**Re: PRE-SIGNATURE FINAL ACTION MEMORANDUM FOR TAYLOR
BOULEVARD BRIDGE (SITE 30), NAVAL WEAPONS STATION SEAL BEACH
DETACHMENT CONCORD, CONCORD, CALIFORNIA**

**Action Memorandum for
Taylor Boulevard Bridge Disposal Site
(Site 30)**

**Naval Weapons Station Seal Beach
Detachment Concord
Concord, California**

ATTACHMENT B
EXECUTIVE SUMMARY FOR THE FINAL ENGINEERING EVALUATION/COST
ANALYSIS (EE/CA) NON-TIME CRITICAL REMOVAL ACTION FOR TAYLOR
BOULEVARD BRIDGE DISPOSAL SITE (SITE 30) NAVAL WEAPONS STATION
SEAL BEACH DETACHMENT CONCORD, CONCORD, CALIFORNIA, AND
RESPONSES TO PUBLIC COMMENTS ON FINAL EE/CA

FIGURE 6
REMOVAL OF CHEMICALS OF CONCERN
COLLOCATED WITH LEAD
 ACTION MEMORANDUM
 FOR THE TAYLOR BOULEVARD BRIDGE (SITE 30)

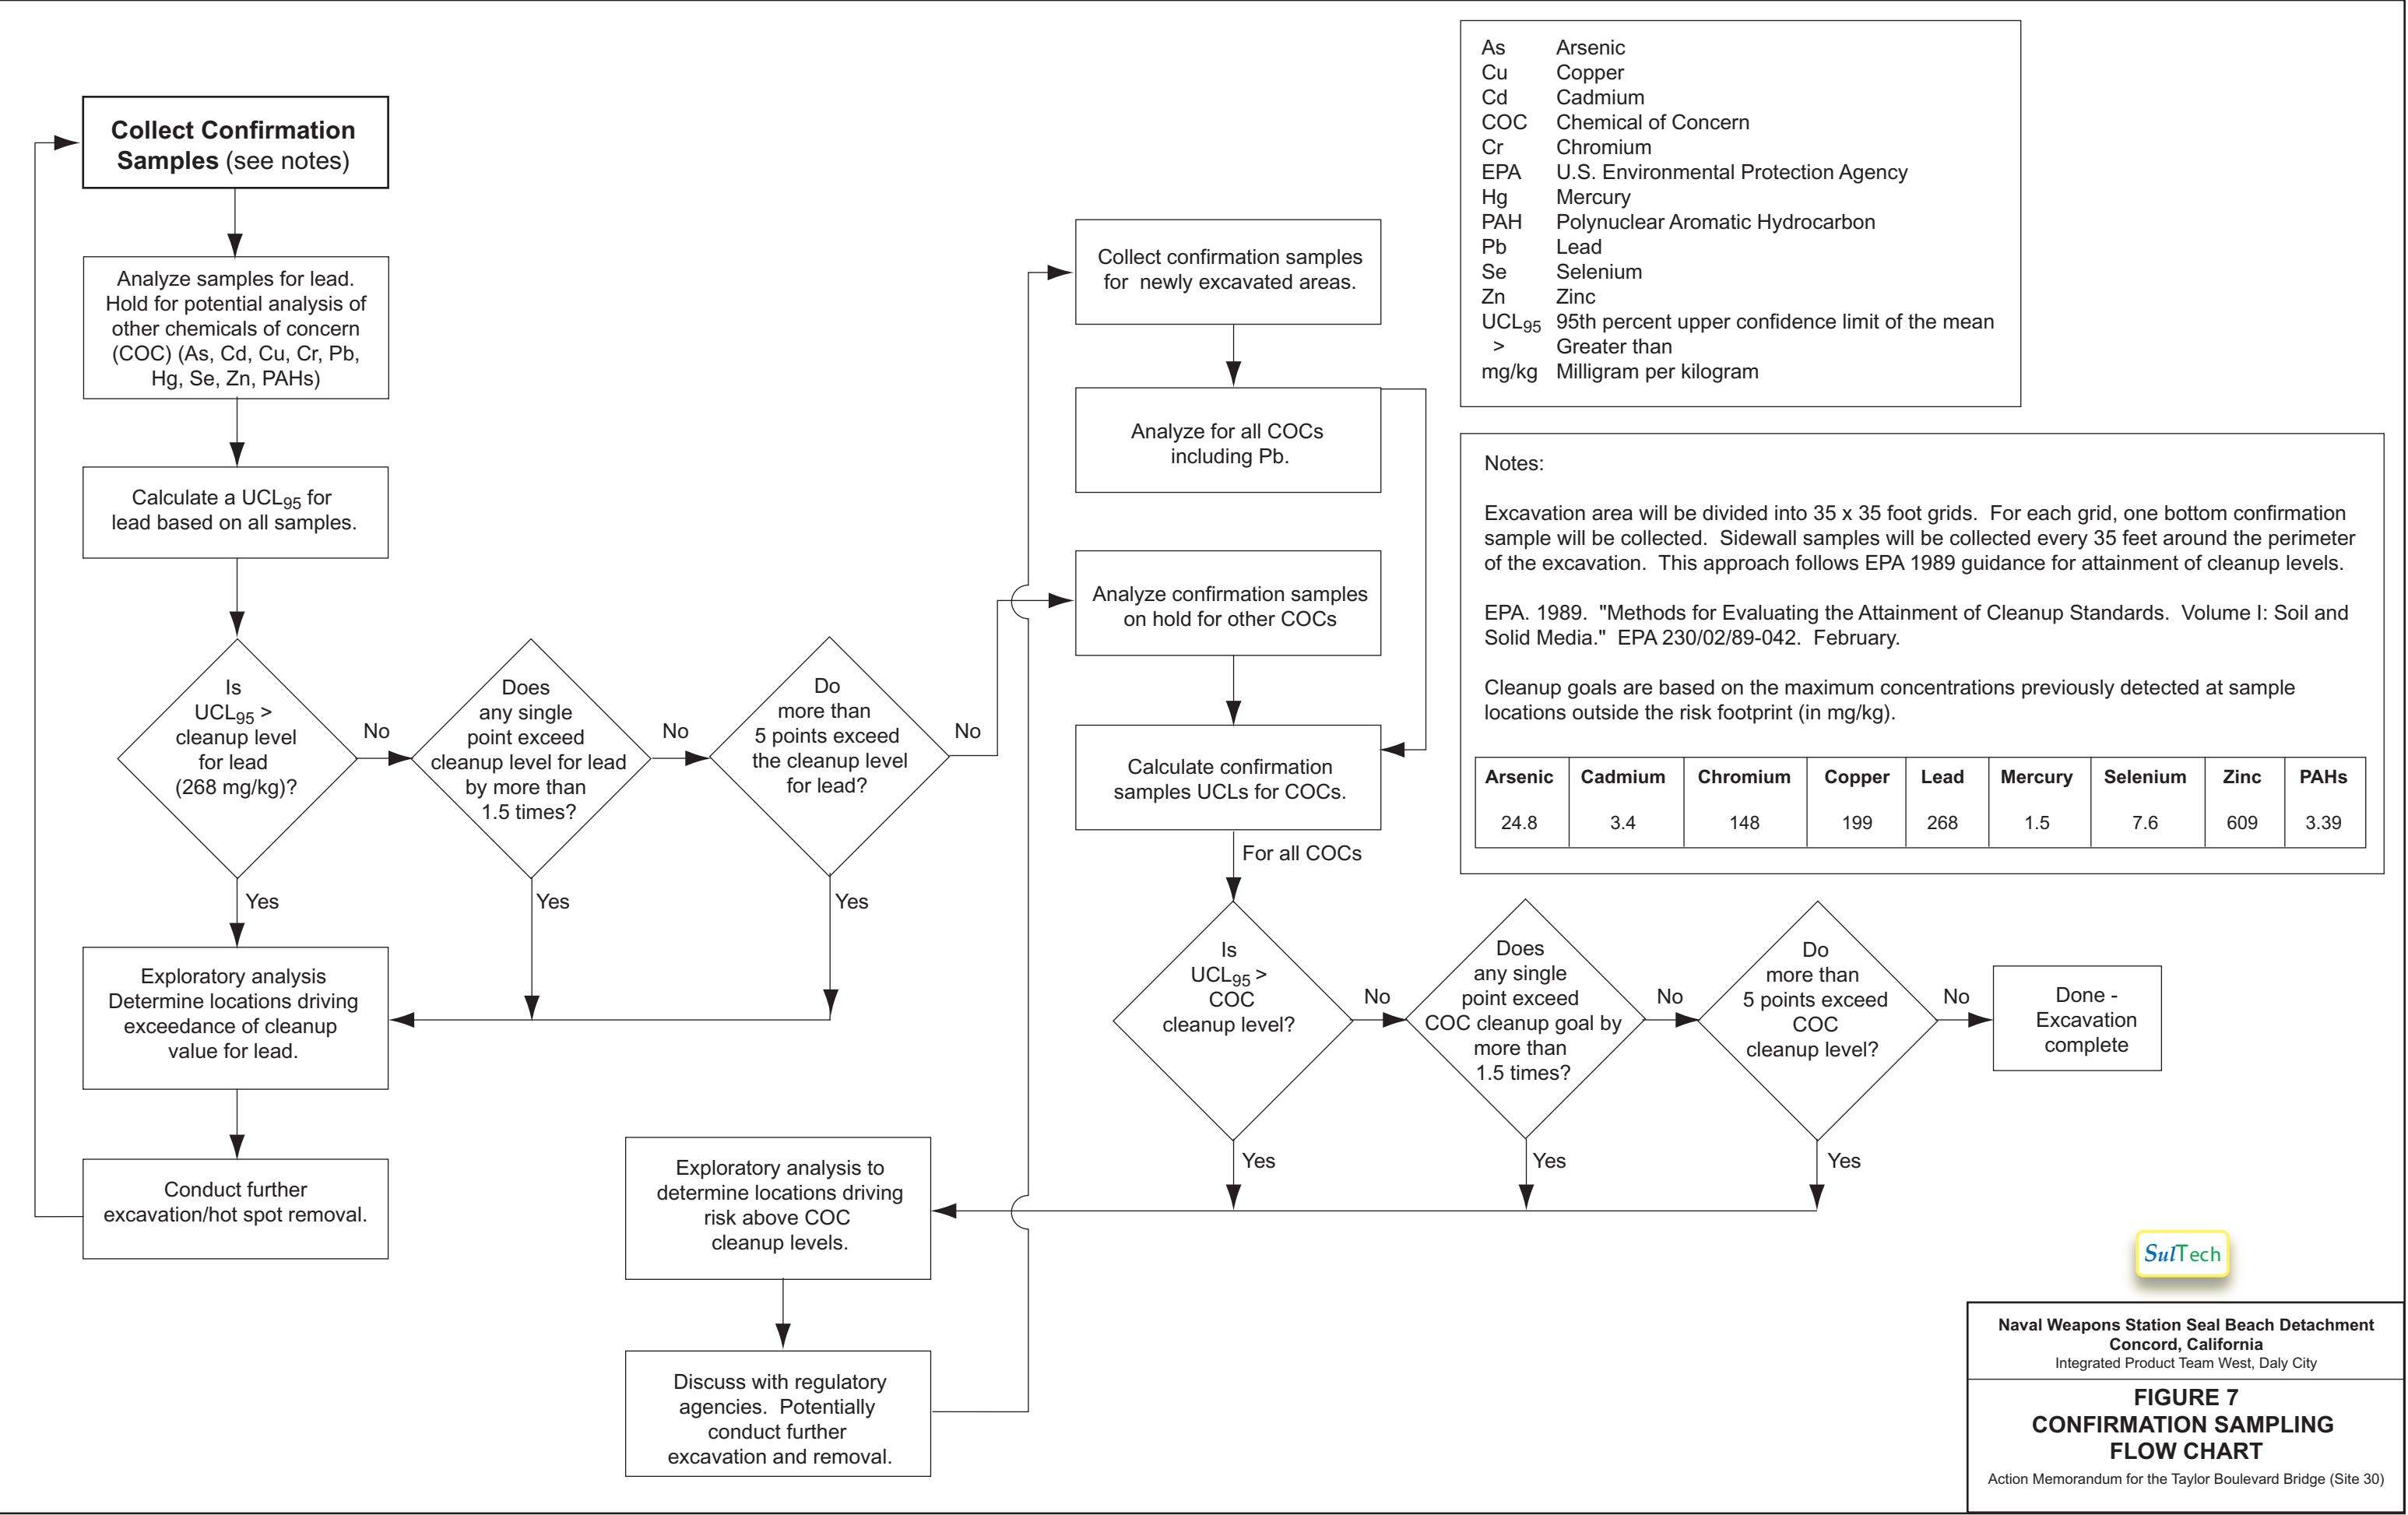
9. **Comment:** Attachment A, Figure 6. The use of a logarithmic scale for the y-axis (maximum concentrations) would be helpful given the wide range in concentrations.

Response: Comment noted. The purpose of the figure is to show that if elevated concentrations of lead are removed, elevated concentrations of other COCs would be removed. Plotting the data on a logarithmic scale does not provide sufficient detail to illustrate this concept. However, [Figure 6](#) has been revised in the final action memorandum to reflect the change in the excavation footprint. Also for DFG information, a revised [Figure 6](#) with the y-axis plotted in a logarithmic scale is attached to these responses to comments.
